Title **On the use of postamble for the relay link**

Date Submitted **2007-01-08**

Re: Response to call for technical contributions regarding IEEE Project P802.16j

Abstract This contribution proposes the use of postamble for the relay link.

Figure xx Example of minimum configuration for an in-band non-transparent frame structure

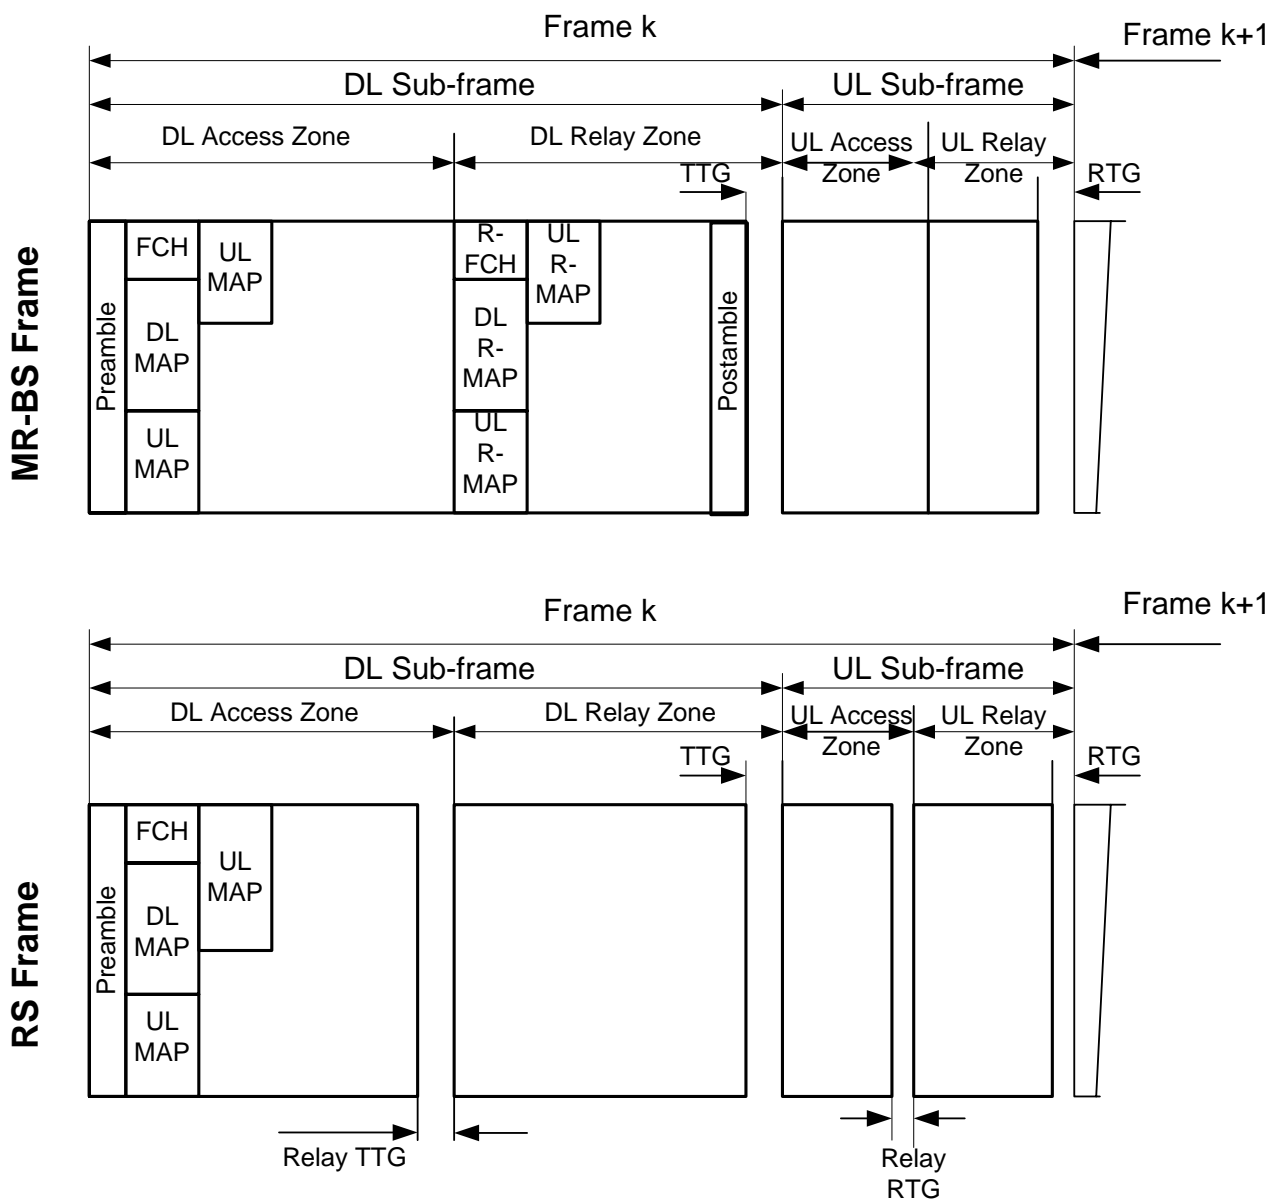
[Replace the Figure xx at subclause 8.4.4.7.2.1:]

The relay link amble, when present, shall be located at the end of the relay zone.
